JLRTB02012NAS1

TECHNICAL BULLETIN

'Gearbox Fault Detected' Displayed On The Instrument Panel Cluster (IPC)

MODEL:	MODEL YEAR:	VIN:	ASSEMBLY PLANT:
I-PACE (X590)	2019-2020	F60094-F80069	Graz (Austria)

E256857

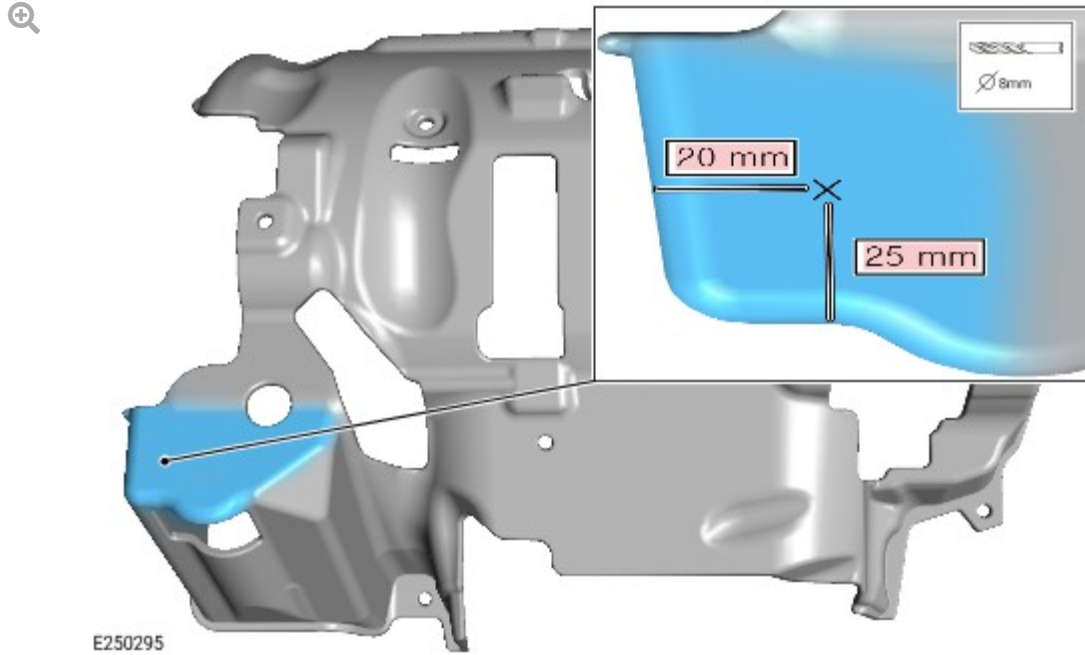
- ■ If the park lock actuator connector (C1YE113A) wiring is found to be damaged, as per the illustration, **continue to step 2.**

3. An Electronic Product Quality Report (EPQR) must be submitted to provide a clear photograph of the original damaged wiring harness installed on the vehicle. See step 1 for example photographs.

Renew the front compartment wiring harness (see TOPIx Workshop Manual section 418-02: Wiring Harnesses - Removal and Installation - Front Compartment Wiring Harness).

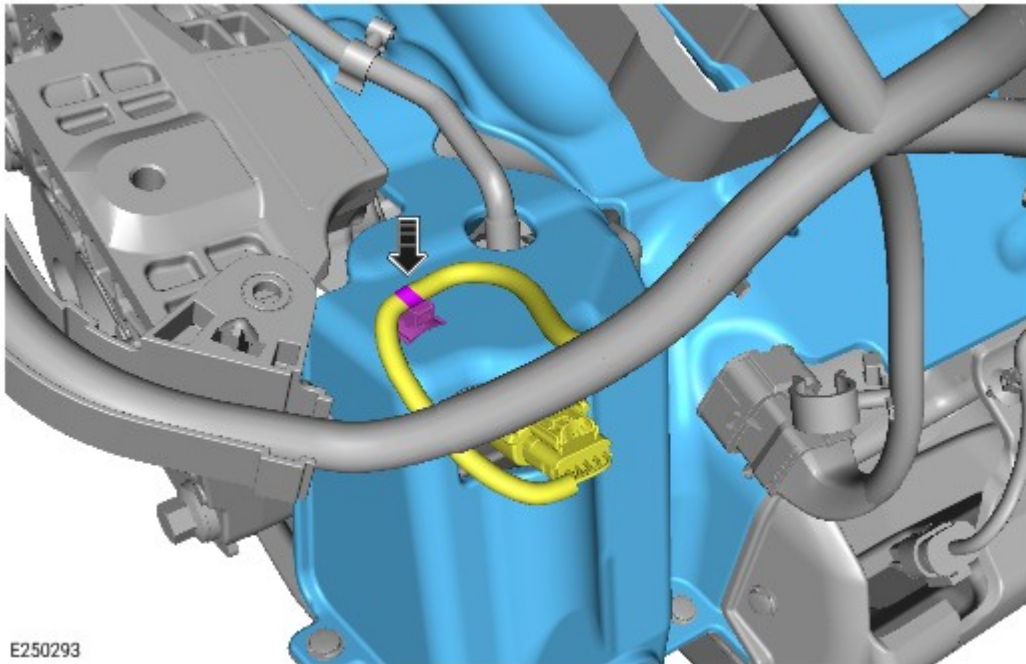
Using a suitable tool, create a hole in the EDU upper Noise, Vibration and Harshness (NVH) cover, as shown in the illustration.

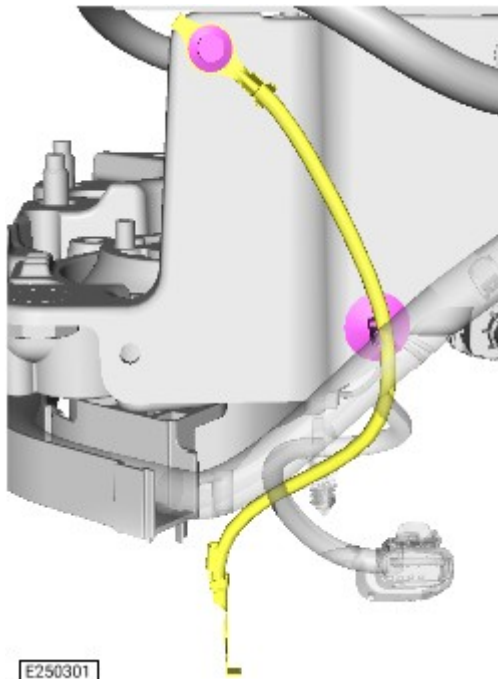
During the installation of the front EDU, make sure the new wiring harness clip is installed in the NVH cover, as shown in the illustration.

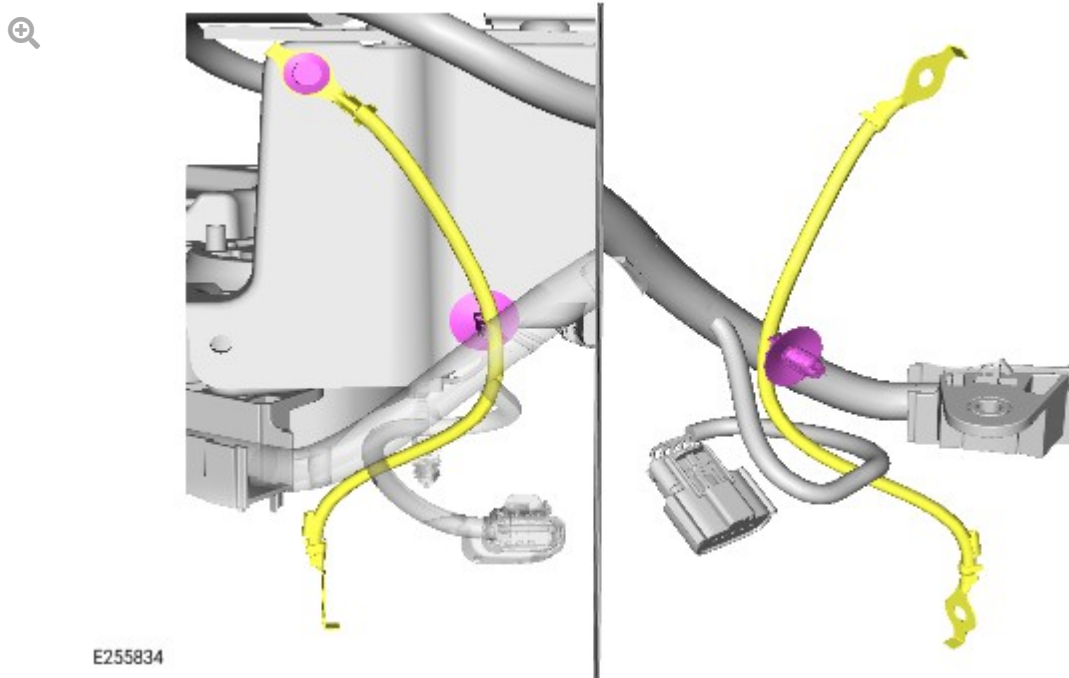
Make sure the new front EDU ground cable is routed through the loop formed by the park lock actuator break out harness, as shown in the illustration.

Install the new front EDU ground cable.

- ■ Secure the ground cable with the retaining clip.
- ■ Tighten the bolt.
 - ■ Torque: **24 Nm**
